# Access Compliance Report

## Public Rights-of-Way

### (Curb Ramps)

Intersection ID: 30551	Main Street: EDENDERRY_DR	Cross Street: WEDDINGTON_RD	Location: SW
ADA ID: B0092DAE3BCB	Ramp Type: Perp	Initial Pass/Fail: Fail	Overall Compliance: No
		Severity Score: 10

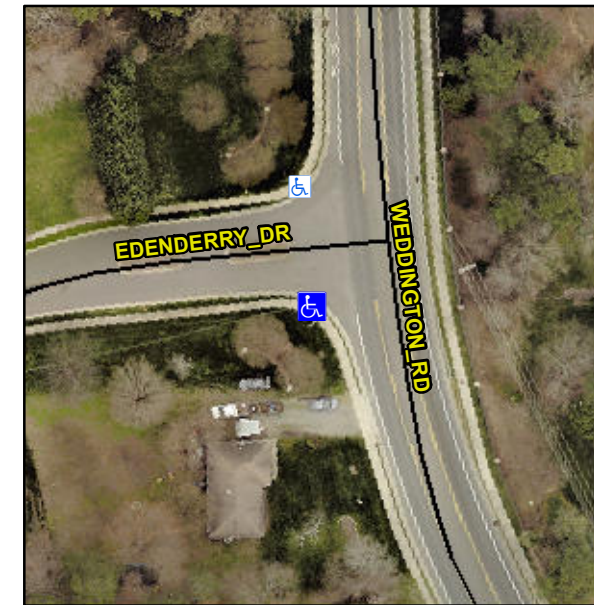
**Not Found, R304.5.1, R304.5.3**

Compliance	Description	Data	Compliance	Description	Data
N/A	Ramp Length (in)	76.0	Yes	Ramp Slope (%)	5.3
No	Ramp Width (in)	47.0	No	Ramp XSlope (%)	3.7
N/A	Flare Type LT	N/A	N/A	Flare Type RT	N/A
N/A	Flare Slope LT (%)	N/A	N/A	Flare Slope RT (%)	N/A
N/A	Flare Traversable LT?	N/A	N/A	Flare Traversable RT?	N/A
N/A	Landing Length (in)	N/A	N/A	DWS Provided?	N/A
N/A	Landing Width (in)	N/A	N/A	DWS Contrast?	N/A
N/A	Landing Slope (%)	N/A	N/A	DWS Length (in)	N/A
N/A	Landing X Slope (%)	N/A	N/A	DWS Full Width?	N/A
N/A	Landing Curb? (Y/N)	N/A	N/A	DWS Offset (in)	N/A
N/A	Shared Landing?	N/A			
N/A	Gutter Ponding?	N/A	N/A	Gutter Slope (%)	N/A
N/A	Gutter Lip Ht (in)	N/A	N/A	Gutter X Slope (%)	N/A
N/A	Painted X Walk1?	No	N/A	Painted X Walk2?	N/A
	X Walk 1 Direction	To N		X Walk 2 Direction	N/A
N/A	X Walk 1 Width (in)	N/A	N/A	X Walk 2 Width (in)	N/A
	X Walk 1 Slope (%)	0.0		X Walk 2 Slope (%)	N/A
	X Walk 1 X Slope (%)	4.8		X Walk 2 X Slope (%)	N/A

**Remove & Replace Entire Ramp.**
